TMI_908-GW(2)-01

Issue Identifier	Age IR	Age	Age Group / Order	Reference to Information Request	
TMI_908-GW(2)-01	GW(2)-01	1	CEA Agency	Reference to EIS Guidelines:	Part 2, Sections 9.1.1 and 9.1.2
				Reference to EIS / Appendix	n/a
				Cross-reference to Round 1 IRs	TMI_72-GW(1)-09, TMI_74-GW(1)-11, TMI_75-GW(1)-12, TMI_83-GW(1)-20, TMI_115-SW(1)-29
				<p>Identified Risks</p> <p>The groundwater model has a number of deficiencies, listed below, which raise uncertainties with the modelling exercise, the outputs of the model, and the effects assessments that incorporate those model outputs. These concerns are also tied with concerns raised in other IRs related to characterization of geochemistry on the site (see CEAA 31, 24 to 26 and 33), cover options for TSF and WRSAs (see CEAA 9 to 11 and 30), and TSF base and liner (see CEAA 14 and 29).</p> <ol style="list-style-type: none"> 1) Recharge rate uncertainty Recharge was based on very limited field observations which were conducted during unusually dry years (Appendix M of the revised EIS, Section 3.2 and Figure 9). Recharge rates have important implications for modelling the quantity of seepage. 2) Recharge rate uncertainty (WRA)

TMI_951-GW(2)-01B_Figure 1
Thickness of Basal Sand

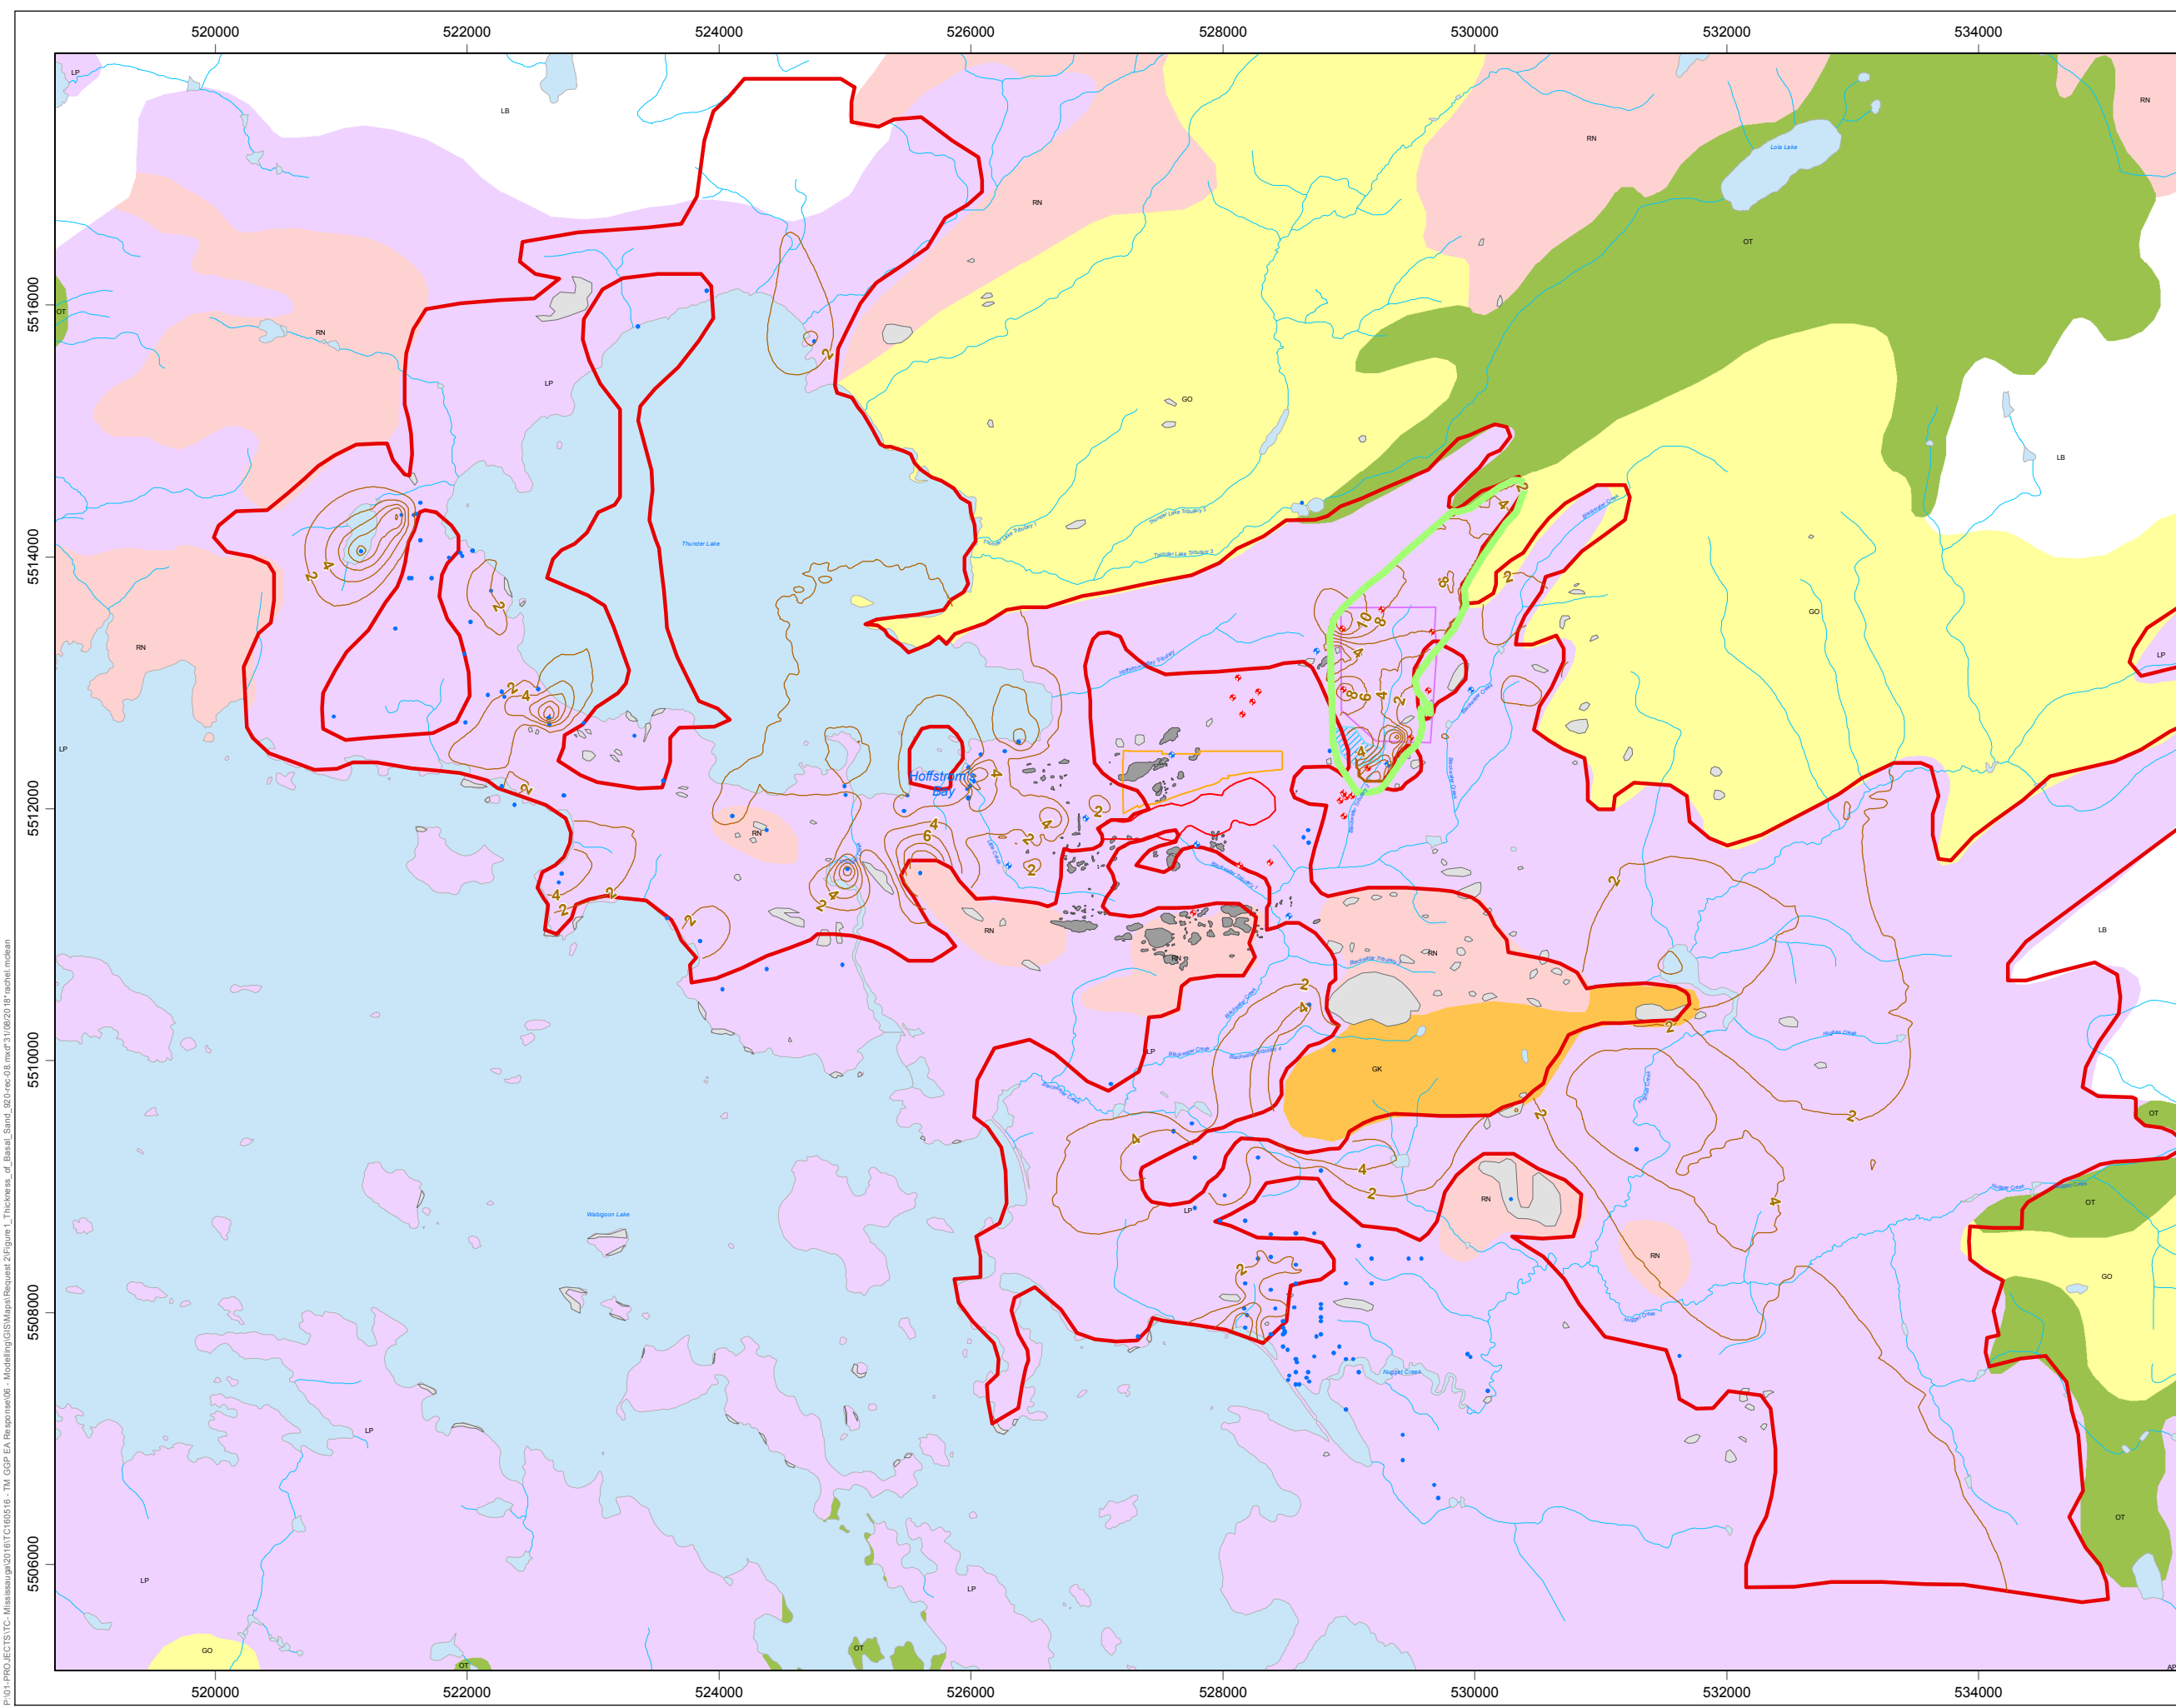
Issue Identifier	Age IR	Age	Age Groundwater Order	Requester's Information Request Response
				<p><u>Issue Identifier</u></p> <p>A. Provide an updated groundwater model that addresses all seven of the concerns raised in the “Context and Rationale” for this IR. Incorporate the findings from the IRs # MW(2)-08 and GW(2)-02 to GW(2)-04 in the revision of the model.</p> <p>B. Provide the potential range in seepage volumes (e.g. based on sensitivity analyses) from the TSF and WRSA. Also provide travel times for this seepage to various receptor locations. Include in this assessment, an explanation of how seepage volumes would be expected to flow through various geologic layers.</p> <p>C. Determine the capture efficiency of the seepage collection system, and assess the efficiency based on different ditch depths, and whether efficiency can be improved through the use of additional mitigation measures such as pump-back wells.</p> <p>D. Reassess the changes in water quality from seepage emanating from the TSF and WRSA and an updated groundwater model, taking the responses from Questions A to C into consideration.</p> <p>E. Revise the effects to fish and fish habitat and Indigenous health from impacted private groundwater wells taking the response from Question D into consideration.</p> <p>F. Describe additional mitigation measures to prevent adverse effects to fish and fish habitat and Indigenous health from impacted private groundwater wells, if necessary, taking into consideration the response to Question E.</p> <p>G. Characterize residual effects, if any, after the mitigation measures described in Question F have been implemented.</p> <p>H. Update the follow-up program for potential effects to fish and fish habitat and Indigenous health from impacted private groundwater wells, including objectives and any monitoring measures that will be implemented to verify the predictions of effects and evaluate the effectiveness of the proposed mitigation measures. If follow-up is not required, provide a rationale.</p> <p>I. Incorporate the findings from this IR into the revision of seepage water quality assessment requested in IR# MW(2)-06.</p> <p>THIS IR SUPERSEDES IR# GW(2)-01.</p> <p><u>Response</u></p> <p><u>Part A:</u></p> <p>Treasury Metals had undertaken a review of the inputs, assumptions and outputs of the groundwater model in response to the seven concerns raised in the “Context and Rationale”. As detailed below, the review did not identify deficiencies in the assumptions and inputs that would warrant updating the groundwater model. The groundwater model used for the Goliath Gold Project was used to characterize the transport of seepage from the WRSA and TSF, as well as the rate of inflow into the open pit and underground mine workings. Detailed justification for retaining the</p>

Issue Identifier	Age IR	Age	Age Groundwater Order	Request Reference Information Request Response
				<p>Goliath Gold open pit, and the Victor kimberlite deposit is situated in several karstic dolostone formations. The groundwater pumping rates for the Victor Diamond open pit are two order of magnitudes greater than predicted for the Goliath Gold open pit.</p> <p>Therefore, it would not be reasonable to expect the Goliath Gold Project to collect as many of hydrogeological/geotechnical measurements as were collected for the Detour Gold, Rainy River Gold or Victor Diamond mining projects.</p> <p>Regarding the information in Table 5.6.2.2-1 of the revised EIS (April 2018), these data are almost all correct and are the same as given in the AQTESOLVE analysis sheets provided in Appendix C of Appendix M of the revised EIS (April 2018) with the geological data corresponding to the borehole logs of Appendix C of Appendix M of the revised EIS (April 2018).</p> <p>The exception is for Well 5A where the hydraulic conductivity should have been rounded to 1.1×10^{-6} m/s rather than 1.0×10^{-6} m/s. The geometric mean and arithmetic mean should be 9.1×10^{-7} m/s and 9.6×10^{-7} m/s rather than 9.2×10^{-7} m/s and 9.8×10^{-7} m/s, respectively. These typos concerning the means also occur in Section 4.1 of Appendix M of the revised EIS (April 2018). The hydraulic conductivity values are largely representative of silty sands that occur at the base of the overburden and are consistent with published literature (e.g., Freeze and Cherry, 1979). There is one anomalous value (Well 5A), which gave a value of 1.1×10^{-6} m/s, untypical for the screened unit of clay, as noted in Section 4.1 of Appendix M of the revised EIS (April 2018). The log for Well 5A (Appendix A of Appendix M of the revised EIS [April 2018]) shows three split spoons across the screened interval, which all indicate clay. It is possible that the higher than normal hydraulic conductivity may be due to a thin sand or gravel seam occurring between the split spoon samples not being recognized during drilling of the borehole.</p> <p>4. Thickness of the Overburden</p> <p>The upper three (3) layers of the groundwater model correspond to:</p> <ul style="list-style-type: none"> Model Layer 1 is the surface layer and corresponds to the Clay, Sand and Gravel, the upper layer of the Sand-Clay/Silt Sand unit or bedrock knoll, depending on the surficial geology. Model layer 2 corresponds to the Basal Sand unit in the areas where it is expected to be thicker than 0.3 m. The basal band layer is discontinuous layer at the base of the clay, that is, on average, 3 to 4 m thick, when present. Model layer 3 corresponds to the weathered Shallow Bedrock unit, which was assumed to have a uniform thickness of 7 m. It is widely recognized that the shallow weathered and fractured bedrock tends to be the more permeable than the deeper bedrock in a shield crystalline bedrock setting, such as occurs at the Goliath Gold Project. <p>The thickness of the overburden, basal sands vary over the modelling domain based on the available data. TMI_951-GW(2)-01B_Figure_1, TMI_951-GW(2)-01B_Figure_2, and TMI_951-GW(2)-01B_Figure_1 show the thickness maps for the Basal Sands (Model Layer 2), Clay (Model Layer 1) and Sand and Gravel (Model Layer 1 and</p>

Issue Identifier	Age IR	Area	Age Groundwater	Request Reference
				<p>2) respectively. For each of the maps, surface water bodies, private wells and monitoring wells, as well as the mining facilities are shown. Bedrock sits beneath the Basal Sand, Clay, and Sand and Gravel layers, with the upper 7 m identified as weathered and fractured shallow bedrock.</p> <p><u>5. Porosity estimates</u></p> <p>To clarify, 0.01 (or 1%) was used as the kinematic porosity for the shallow bedrock, not the total porosity. When trying to understand the travel times for seepage in bedrock, the parameter of greatest importance is the kinematic porosity (or effective porosity). The kinematic porosity, which describes the ability of a fluid to travel through a media, is always lower than the porosity. Kinematic porosities for weathered bedrock provided in literature (Worthington, Smart and Ruland, 2012), suggests that values in the range of 0.01%–0.1% are possible carbonate aquifers, but posits a value of 1% is possible. The kinematic porosity of 0.01 used for the groundwater velocity calculation (memo to Mark Wheeler, Treasury Metals; “Additional Hydrogeological Information”, dated March 29, 2018, as appended to Appendix M) represents the porosity of open, weathered fractures at the bedrock surface. The Basal Sand at the base of the overburden is discontinuous as noted in the memo referred to above. Nevertheless, as fractures in the shallow bedrock will also be discontinuous, it is correct that flowpaths</p> <p><u>6. Particle Tracking</u></p> <p>Particle tracking has been undertaken with the groundwater model representing the ultimate dewatered mine condition with particles released from the TSF. As described in the response to TMI_911-GW(2)-04, the particle tracking plots for TSF during operations (TMI_911-GW(2)-04_Figure_1) show that, of the seepage leaving the TSF, 46% is captured by the open pit; 34% is captured by the TSF perimeter drains; 14% is captured by the minewater pond, and 6% escapes the operations area and reports to Blackwater Creek. The proportion that escapes the operations area to report to Blackwater Creek occurs along the eastern perimeter of the TSF. The particle tracking for the WRSA during operations (see TMI_911-GW(2)-04_Figure_2) indicates that all water seeping from the base of the uncapped WRSA during operations is captured by the open pit.</p> <p><u>7. Sensitivity Analyses</u></p> <p>Sensitivity analyses have already been undertaken with the groundwater model for the shallow bedrock and basal sand as shown in Table 9 of Appendix M to the revised EIS (April 2018). The focus of this sensitivity analysis was on the identification of seepage volumes into the open pit and underground mine workings, instead of the effects on the rates of seepage from the WRSA. As detailed in the responses to TMI_909-GW(2)-02 and TMI_911-GW(2)-04, all of seepage from the uncapped WRSA during operations and closure will be captured by the open pit, and will not reach the receiving environment. The uncapped WRSA scenario will only exist during operations and for a short period of time during closure when a low-permeability dry cover will be constructed over the WRSRA as described in Section 3.16.8. The multi-layer, low permeability dry cover over the WRSRA is intended to reduce the rate of infiltration into the</p>
